Revisions	AP	LP
P01 14.07.16	ADDITIONAL PLANNING INFORMATION	LP
P02 09.03.17	PLANNING AMENDMENT SUBMISSION	NH LP

PLANNING

Client	RFU
Project	TWICKENHAM STADIUM EAST STAND EXTENSION
Drawing title	TYPICAL STREET FRONTAGE 2

Project number	Drawing number	Revision
15735	242	P02

1 ELEVATION
 STREET FRONTAGE DETAILED ELEVATION 2
 1:50

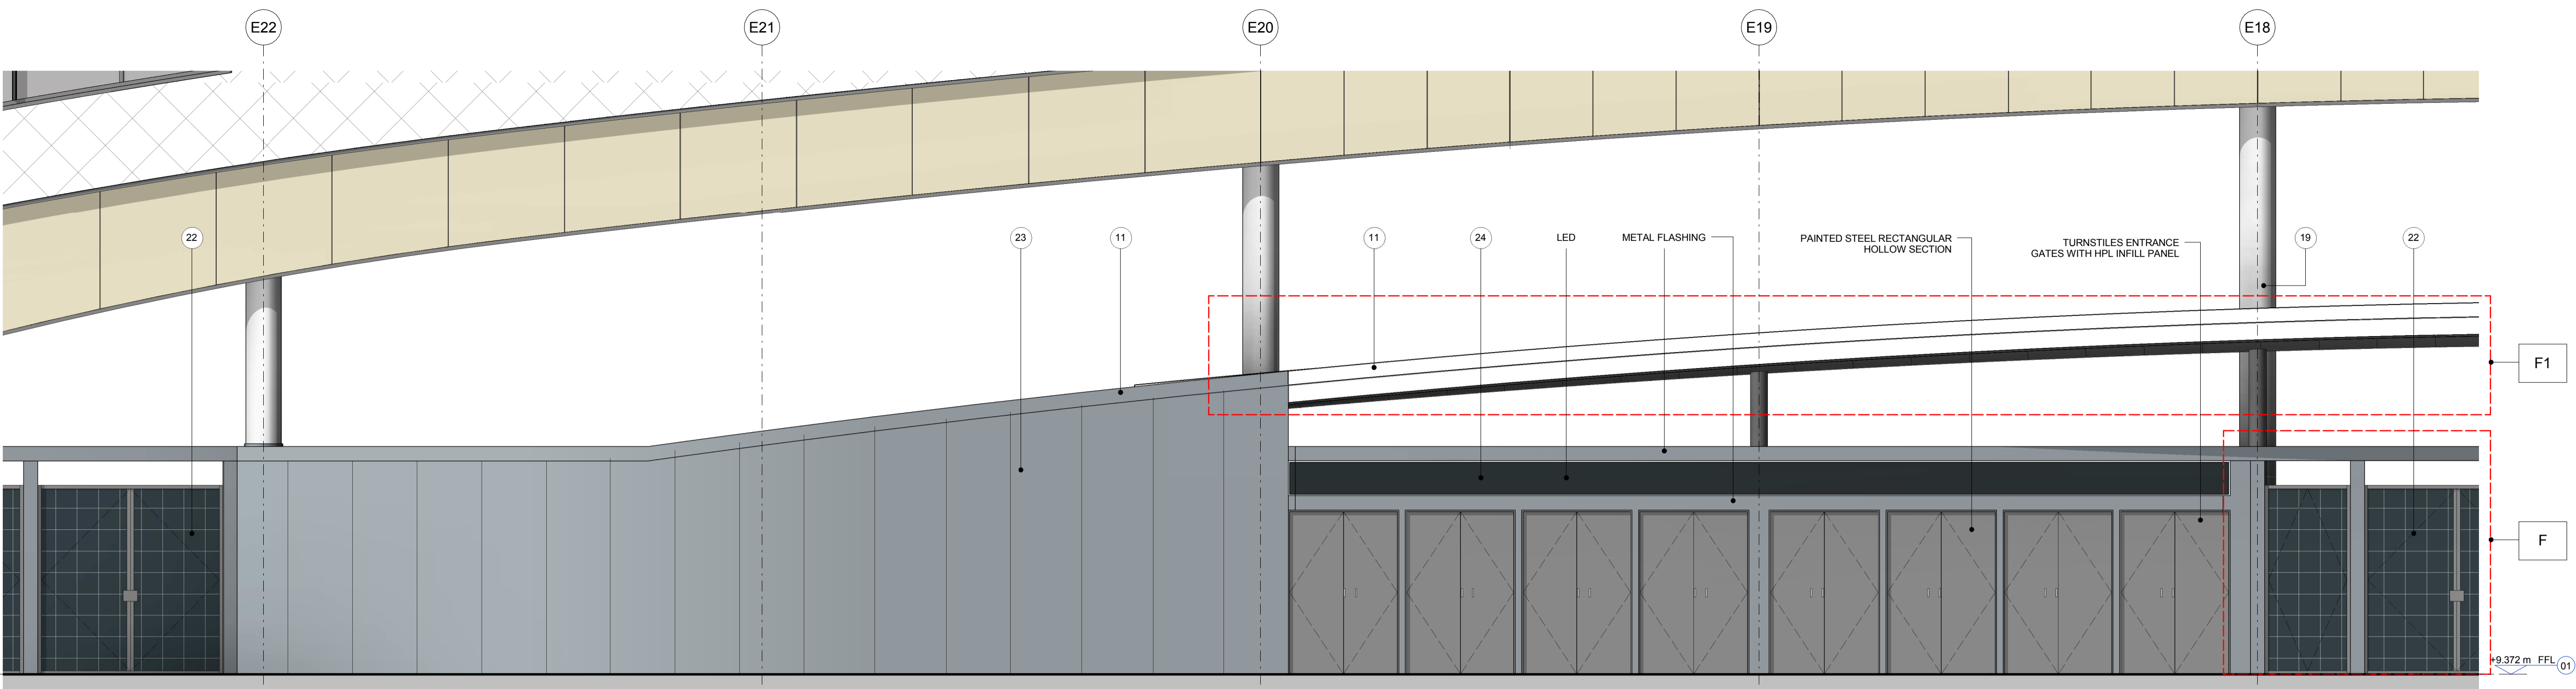
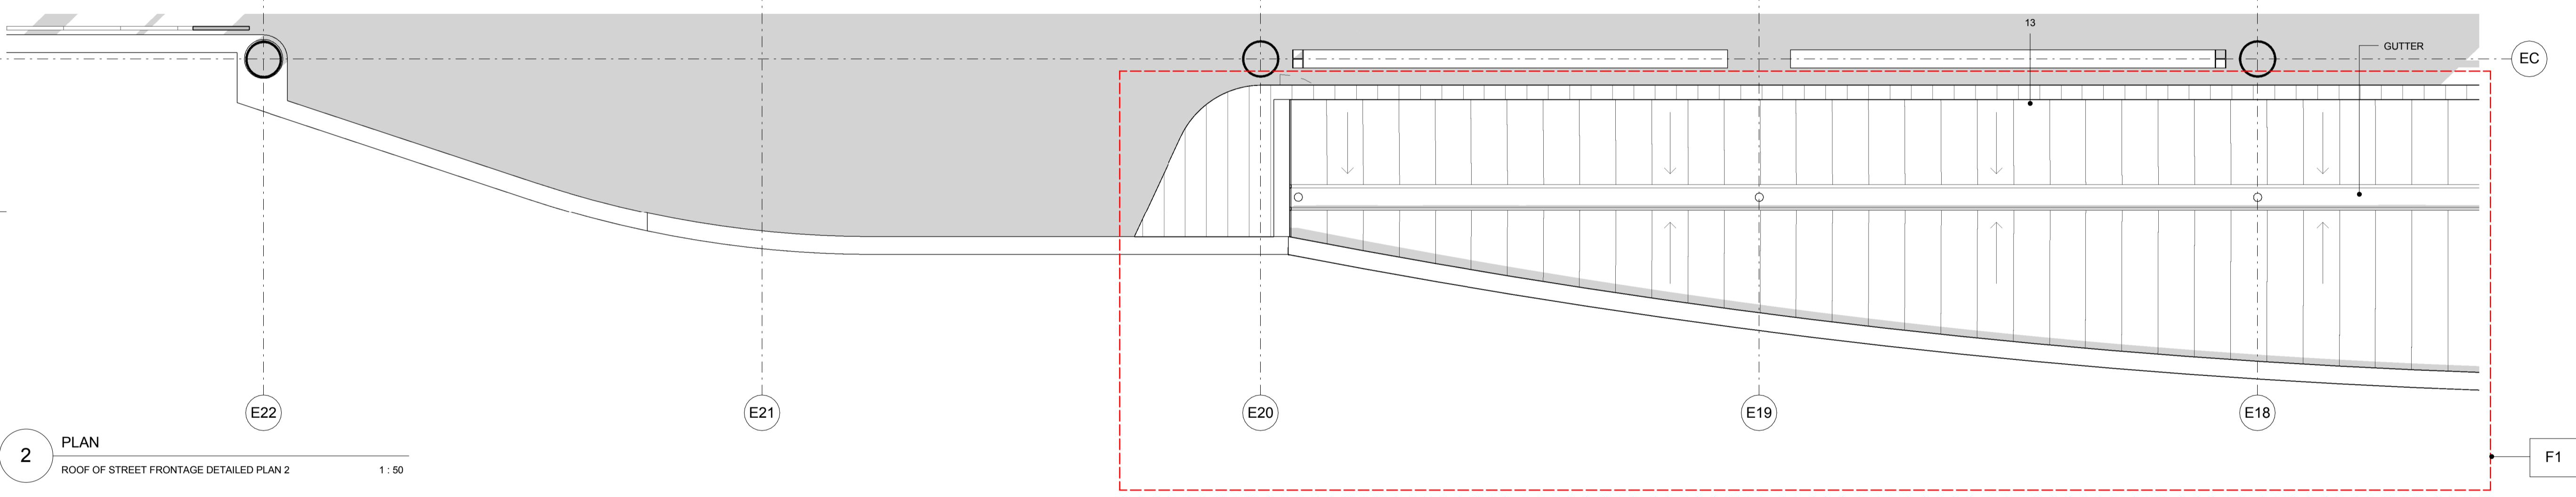
- PLANNING AMENDMENTS**
- A GENERAL AMENDMENTS TO THE SOUTH END. INCREASED SHINGLES CLADDING AREA AND CURTAIN WALL REDUCED ACCORDINGLY.
 - A1 INCREASED SHINGLES CLADDING AREA AND CURTAIN WALL REDUCED ACCORDINGLY.

- A2 REDUCED MASSING AND REVISED INTERFACE WITH THE SOUTH STAND.
 - B PPC LOUVRES LOCATED TO THE BOWL SIDE HAVE BEEN OMITTED.
 - C CURTAIN WALL SETTING OUT REVISED GENERALLY. SILICONE JOINTS TO TRANSOMS AND MULLION REPLACED WITH CAPPED SYSTEM. LEVEL 04 PPC LOUVRES SETTING OUT & HEIGHT REVISED. MONORAIL FOR ABSAILING REMOVED.

- D GENERAL AMENDMENTS TO THE CENTRAL ELEVATION CANOPY AT LEVEL 5A REVISED GENERALLY AND STANDING SEAM REPLACED WITH SINGLE PLY MEMBRANE. SUPPORT COLUMNS TO ROOF CANOPY REVISED. SQUARE FASCIA TO ROOF EDGE.

- D1 LEVEL 5A GLAZED SCREEN EXTENDED IN HEIGHT AND PPC LOUVRES INCLUDED AT LOW LEVEL.
 - D2 INCREASED SHINGLES CLADDING AREA AND CURTAIN WALL AREA REDUCED ACCORDINGLY. FOUR VERTICAL FINNINGS REMOVED.

- D3 PORCELAIN PANELS WITH SLOTTED HOLES FOR VENTILATION REPLACED WITH PPC LOUVRES. EXPRESSED HORIZONTAL PATTERN TO PORCELAIN PANELS OMITTED.
 - E GENERAL AMENDMENTS TO THE NORTH END PORCELAIN CLADDING REPLACED WITH PPC ALUMINIUM CLADDING.

- E1 PORCELAIN CLADDING REPLACED WITH PPC ALUMINIUM CLADDING.
 - E2 GREEN WALL TO THE NORTH END EXTENDED AND PPC LOUVRES REMOVED.
 - E3 INCREASED SHINGLES CLADDING AREA AND CURTAIN WALL REDUCED ACCORDINGLY.

- F FENCELINE, GATE AND PERIMETER COLUMNS SETTING OUT REVISED.
 - F1 CANOPY TO TURNSTILES REVISED.
 - G PORCELAIN PATTERN CHANGED FROM HORIZONTAL TO VERTICAL.

- H PORCELAIN PANELS TO THE SOFFIT OF THE ARCH REPLACED WITH PPC ALUMINIUM PANELS. PORCELAIN PANELS SETTING OUT REVISED.
 - K ROOF TO LEVEL 5A (NORTH END) EXTENDED.

- L GLAZED SPANDREL PANELS REPLACED WITH METAL SPANDREL PANEL. PORCELAIN PANELS REPLACED WITH PPC ALUMINIUM CLADDING.
 - L1 PPC LOUVRES INCLUDED FOR MECHANICAL VENTILATION.
